TLE985xQX(W)

Microcontroller with LIN and H-Bridge NFET Driver for Automotive Applications

This document lists the deviations and application hints of the TLE985xQX(W) “Microcontroller with LIN and NFET Driver for Automotive Applications“.

Figure 1 Application diagram example with C-R-C filters at MONx

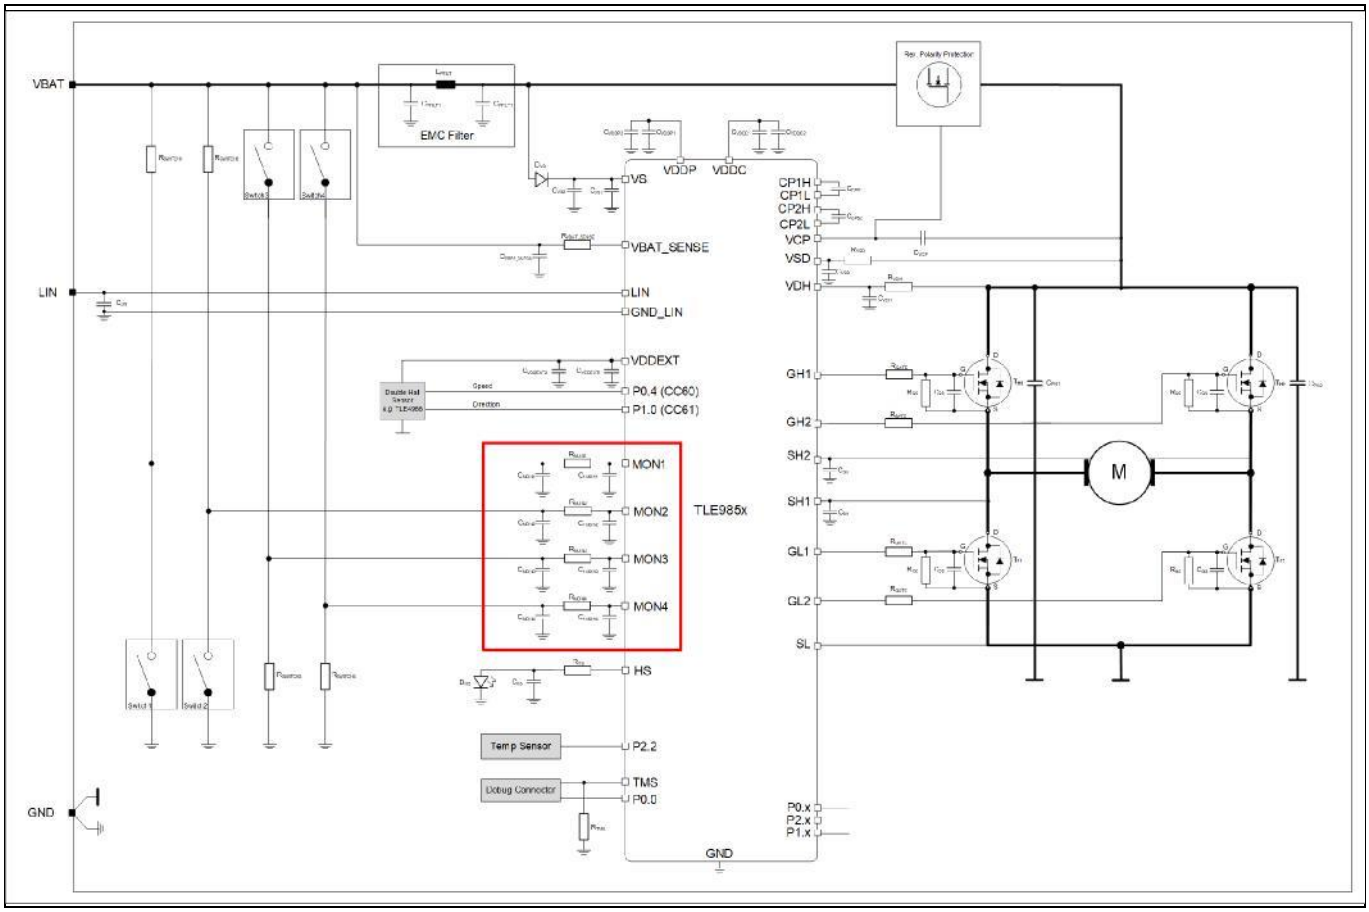
Fast transients on the enabled ADC1 HV-channel could activate the ADC sampling switch, which will lead to a load of 10 kΩ (±20%) on the causing channel.

The activation will increase the input current (> 100 µA @ V_S 13.5 V) on corresponding MONx pin. This increased current can cause a voltage drop via the external resistor. Depending on the size of the resistor the voltage drop can be so high, that a wrong low signal on the MONx will be detected.

To achieve robustness against ISO 7637-3 pulses, the recommended R-C filter from the “Reference data sheet” is sufficient. To increase the robustness an additional 10 nF capacitor (C_{1MONx}) is recommended. This will lead to a C-R-C filter. See Figure 1.
